**The Bishop Strachan School -Contract for Construction**

## Certificate of Substantial Completion

BSS Studio Commons  
298 Lonsdale Road  
Toronto, ON M4V 1X2  
Canada

## ATTACHMENT A - WORK TO BE COMPLETED

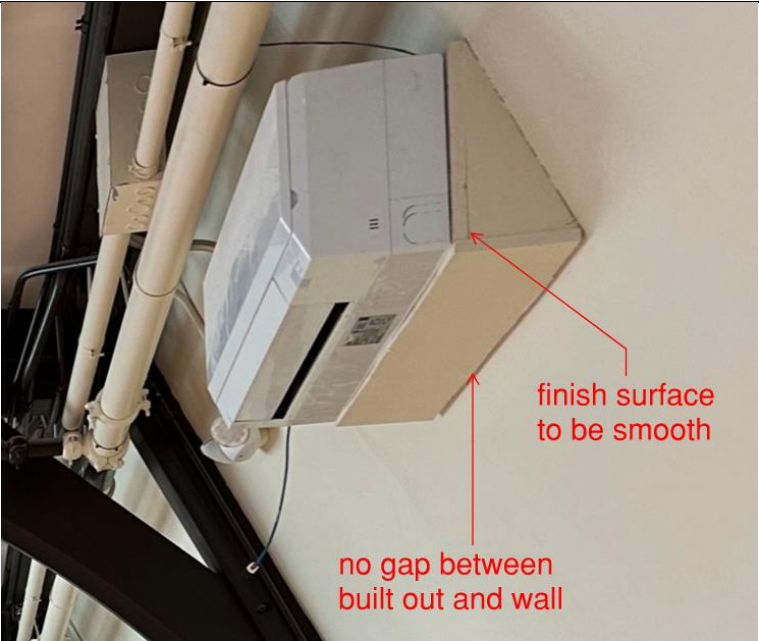
| STUDIO COMMONS |   |  |
|----------------|---|--|
| 3              |  | Paint drywall at door opening white per bulletin 4. Add wall base per bulletin 4.<br> |

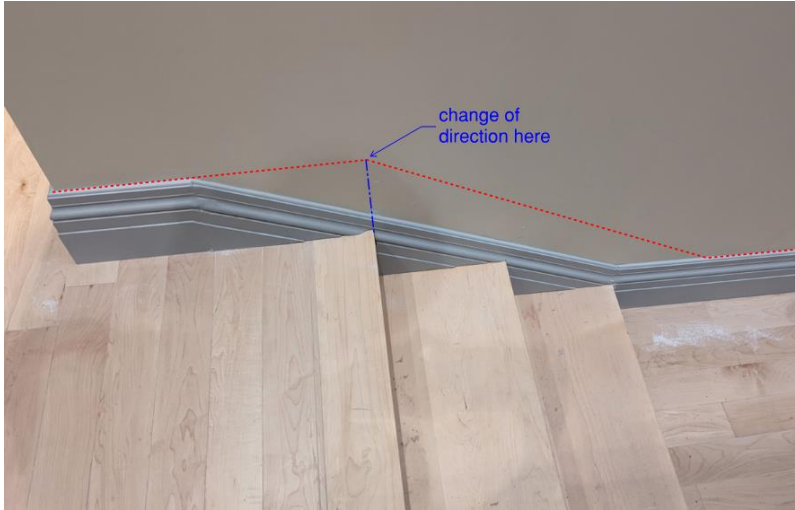
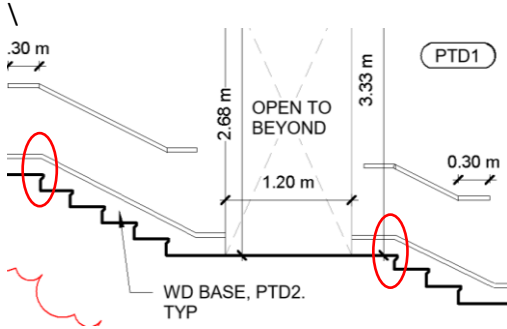
| 12 |  | Paint conduit to match wall color.   |

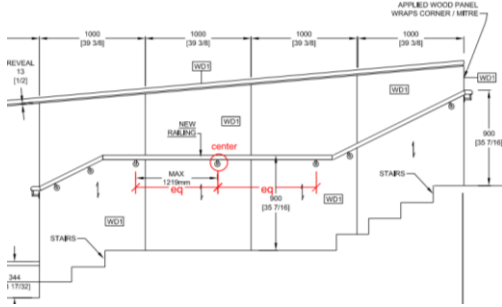
| 14 |  | <p>Re-connect linear fixture cabling.</p>  |

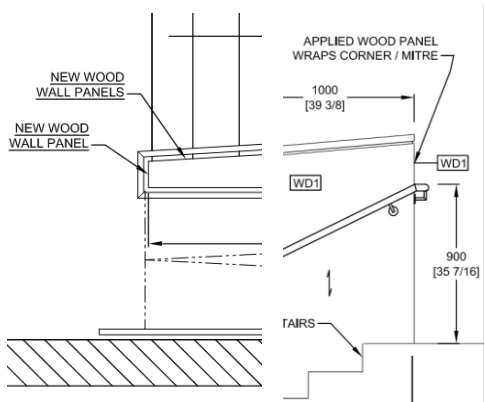
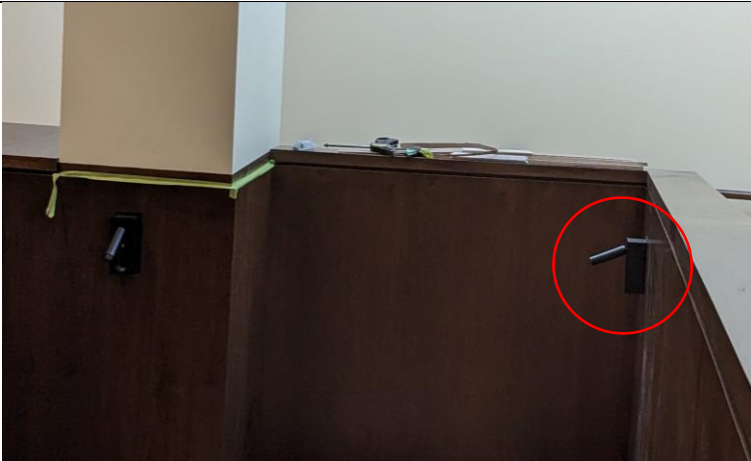
| 15         |    | <p>AC-1 and AC-2 built outs finish surface to be smooth and properly finished.<br/>No gap between built out and existing wall.</p> |

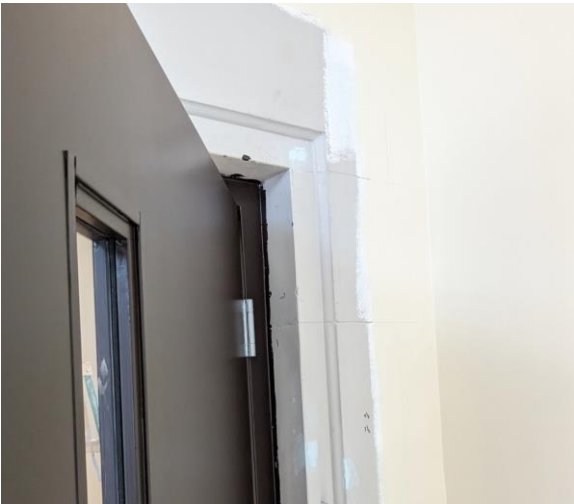
| 22 |  | <p>Paint junction box to match wall color</p>   |
